## Plan finalisation report – PP-2023-1943

Campbelltown Local Environmental Plan 2015 (Map  
Amendment No. 14) - 80 O'Sullivan Road, Leumeah

December 2024

**Figure 2 Post Development Overlay on PMF Hazard Chart**

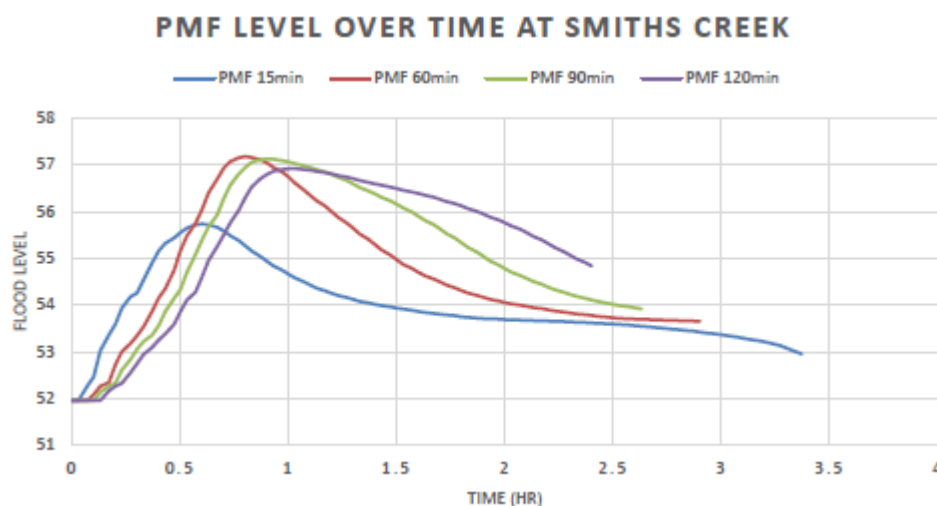
The Flood Risk Assessment advises at Smiths Creek, just downstream of Pembroke Road, the flood event that produces the maximum flood level is the 60-minute duration storm, however the 90 minute and 120 minute duration storms provide similar peak flood levels albeit slightly lower.

At this location the top of bank for Smiths Creek is approximately 54.30m. The PMF event is relatively short duration 'flash flooding'. Flood levels rise above top of bank after 15-30 minutes from the start of the storm, and peak around 45 minutes to 60 minutes. Flood water levels recede back to the top of bank level again after 2 to 2.5 hours.

It is noted as the ground floor level and residential dwellings above level 1 are all above the PMF level, a shelter in place strategy could be adopted for the site. This strategy may also be suitable due to the relatively short duration for flood waters to recede.

**Figure 3 Post Development Overlay – PMF depths map**

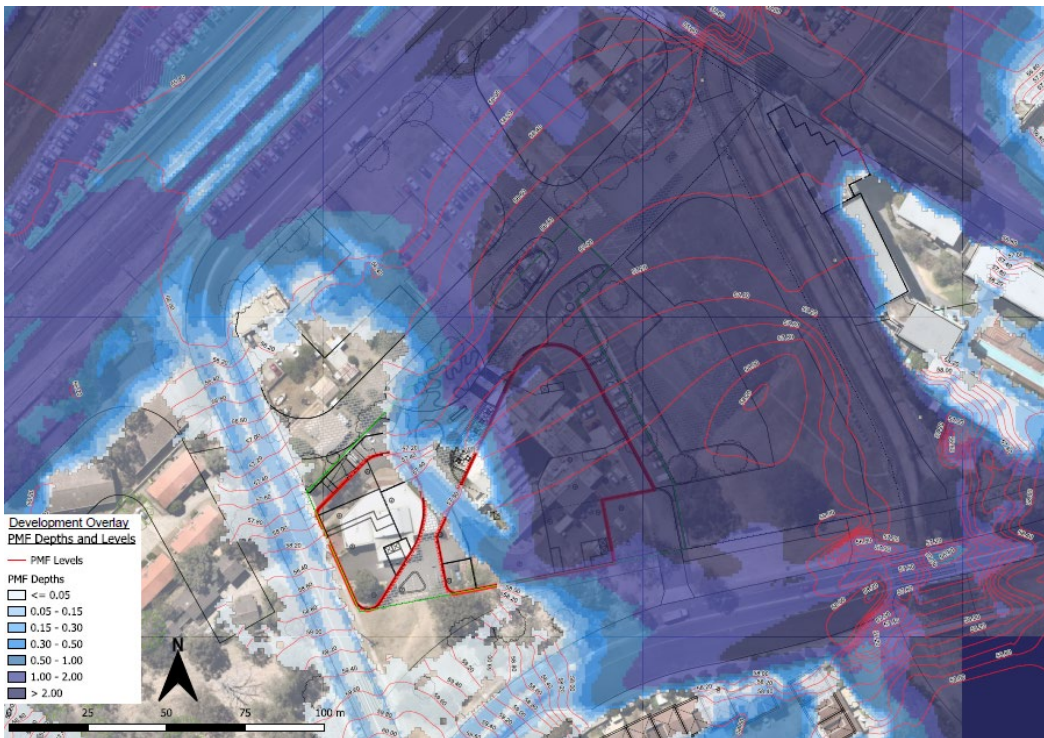
Emergency egress and access to the site during the PMF is available from the main entrance car park from O'Sullivan Road as can be seen at the southwestern boundary of the site. There is only minor flooding in the roadway with shallow depths typically less than 150-200mm and generally low flood hazard which is seen to be acceptable.
